COMMENTS ON THE DRAFT EIR FOR THE PROPOSED NORTHGATE PROPERTY DEVELOPMENT

With regard to the draft EIR and EMP submitted for public review the following comments are offered.

Figure 1: Map of sensitive areas taken from the draft SDF for Kimberley

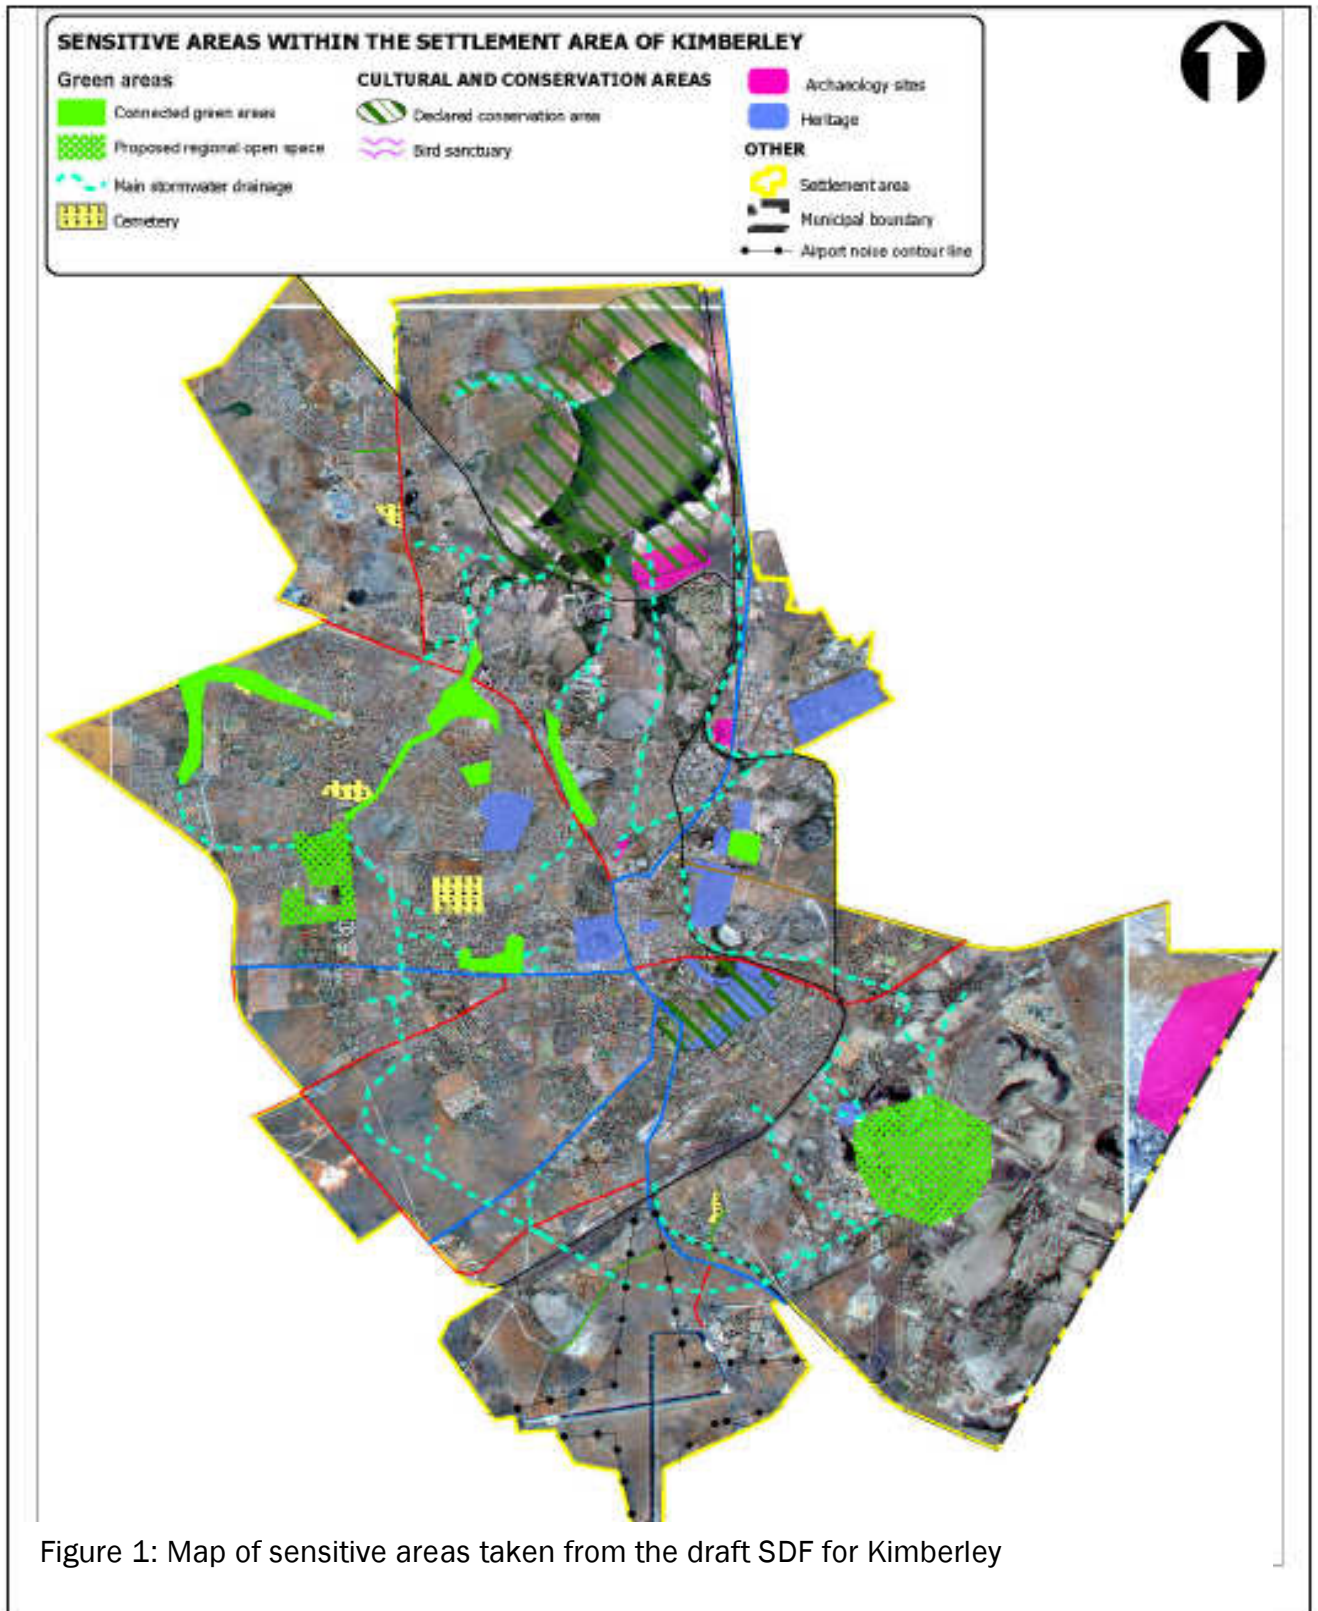
The draft SDF shows part of the proposed development site to be a conservation area (Figure 1), and states that it must be conserved. Therefore development in this area would be inappropriate, and in direct contravention of local planning documentation.

Figure 2: Map taken from SPF document 2004 indicating the buffer zone around the Kamfersdam conservation area.

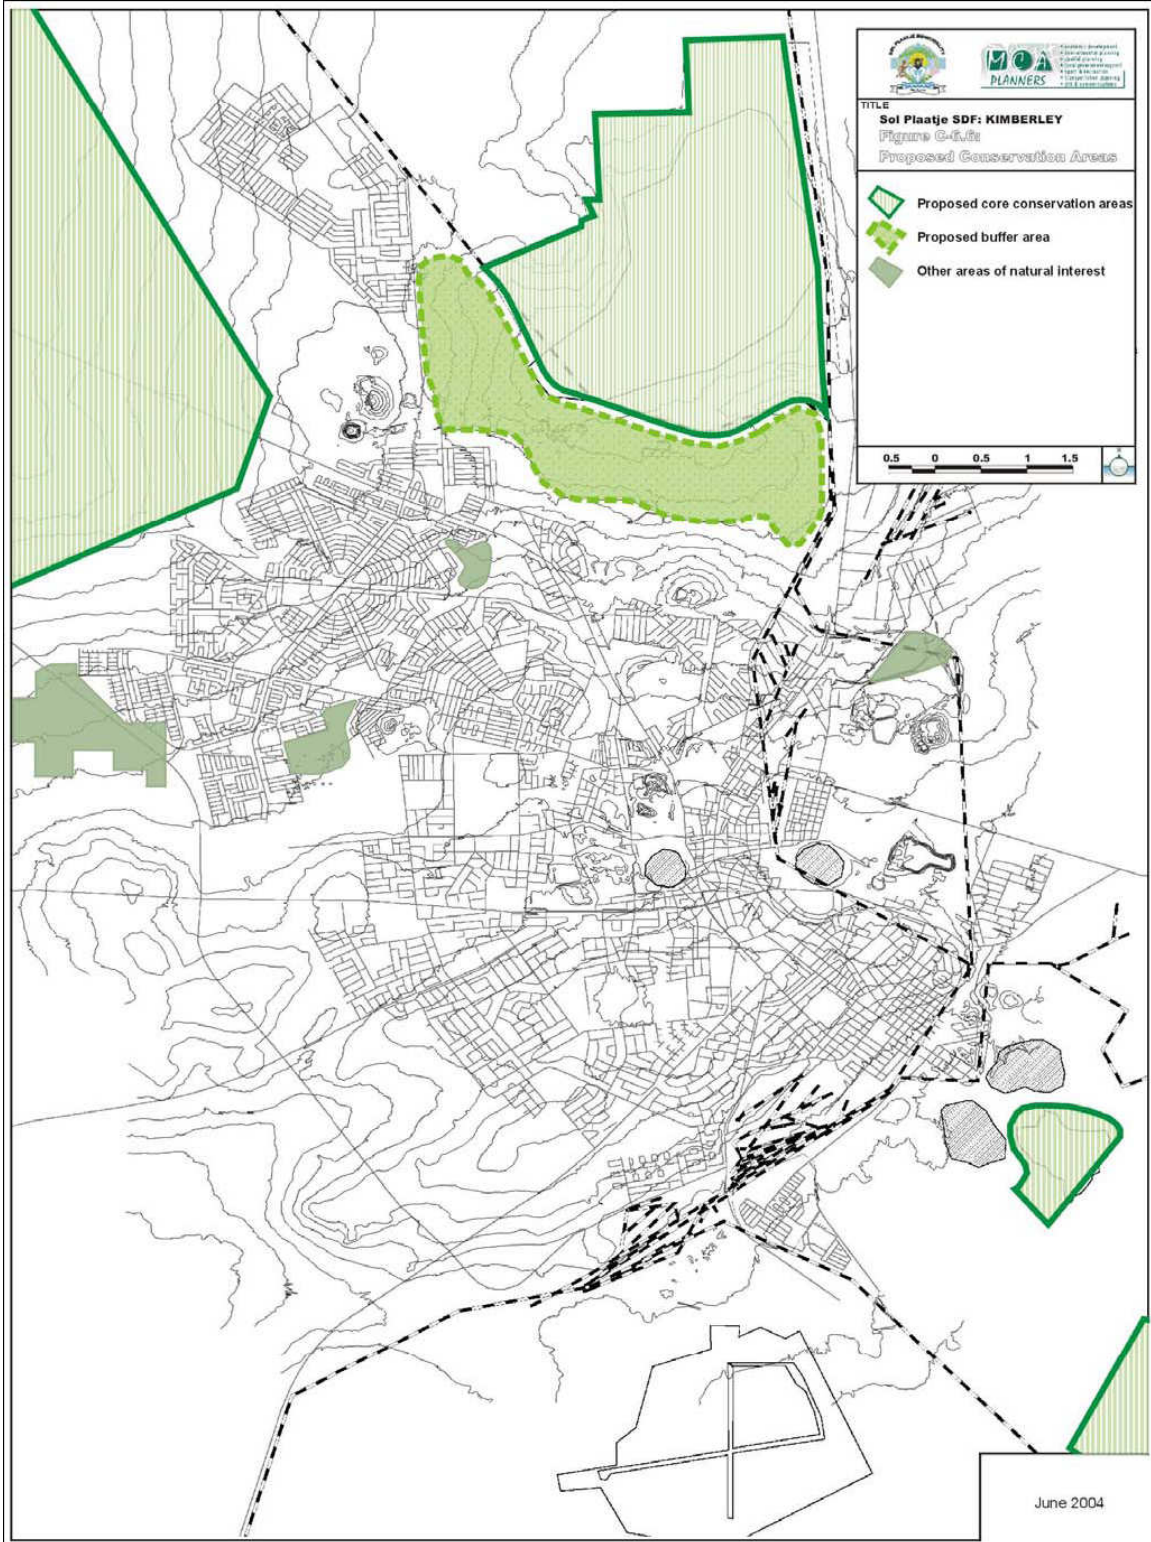
The current SDF (2004) even proposes a buffer zone be maintained between the developed areas and environmentally sensitive dam area (Figure 2). Should development occur in other areas around the dam then surely this buffer zone should be implemented right around the dam? If a buffer zone is required to protect the pan from development to the south then surely a buffer zone would be needed to protect the pan from development to the west and north?

This buffer zone must be included in the development layout and should extend all along the southern western and northern border of the proposed development. Spatial planning forms an important component of an EIA for this kind of development, as development in inappropriate areas constitutes a fatal flaw in the process, and this needs to be highlighted as part of the EIA.

Figure 3: Logic dictates that should development occur to the north and west then a buffer zone as stipulated in the current SDF would need to be extended to the north and west as indicated above.

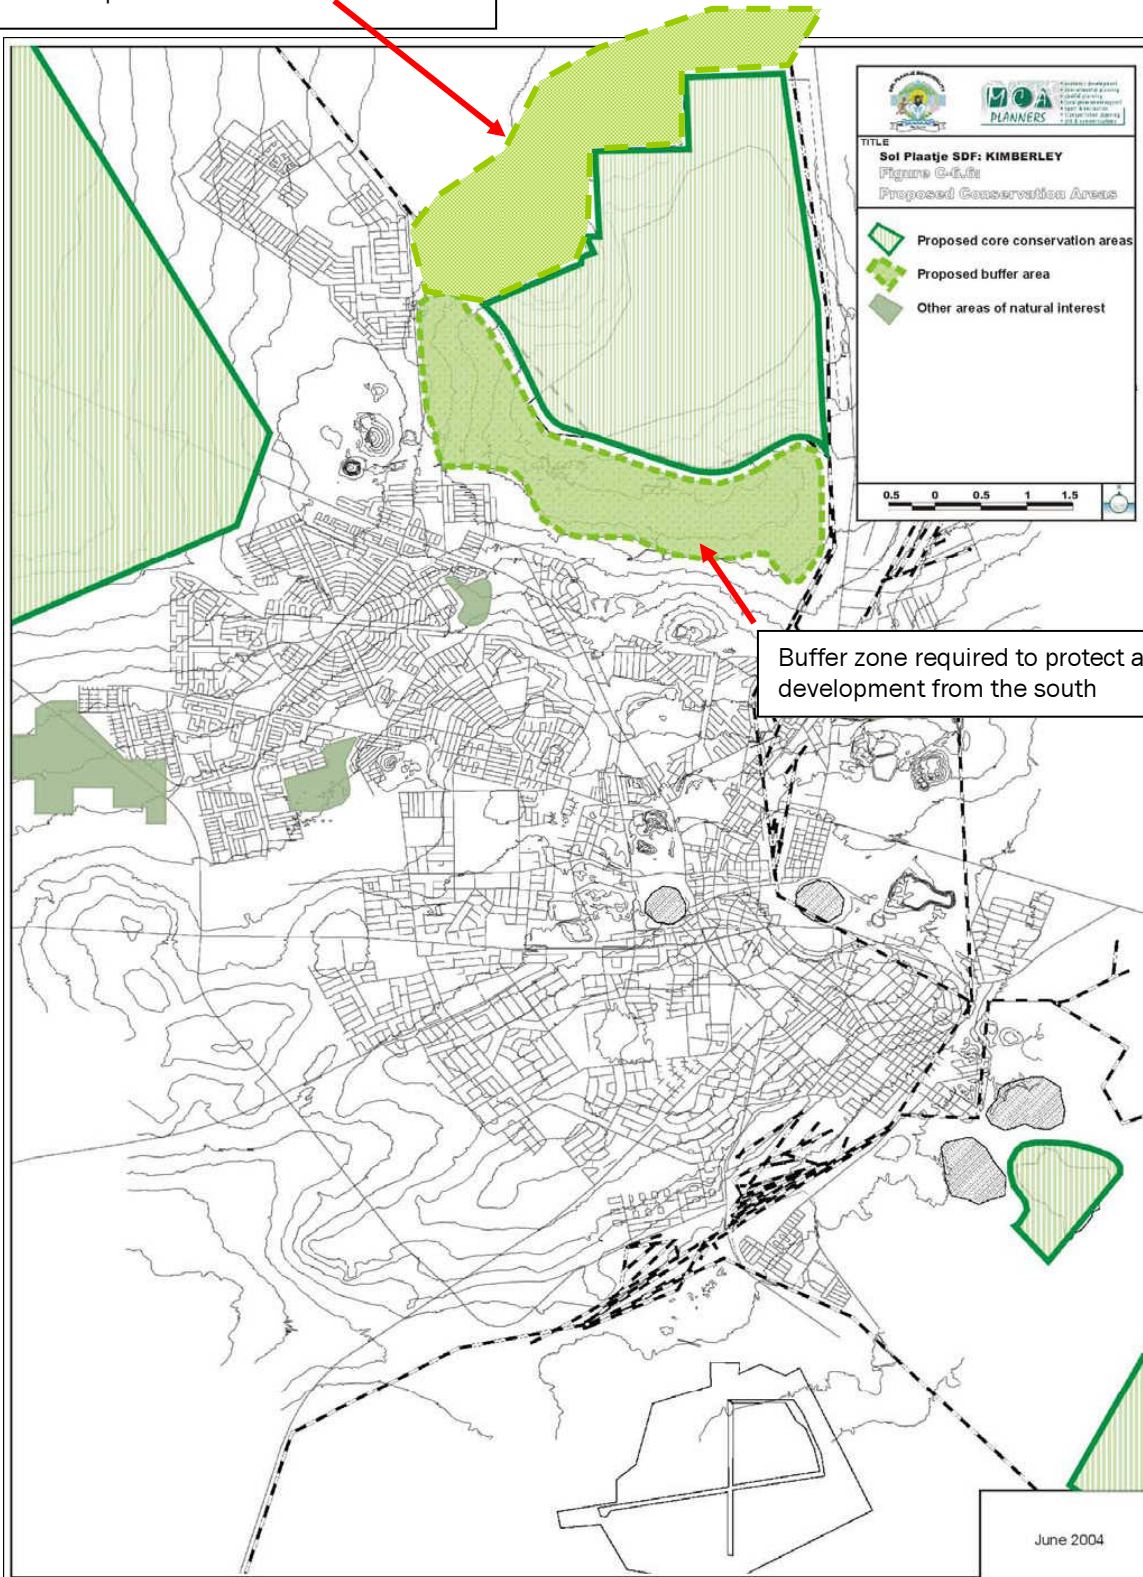
Required buffer zone to protect the dam from the proposed development?

Buffer zone required to protect against development from the south
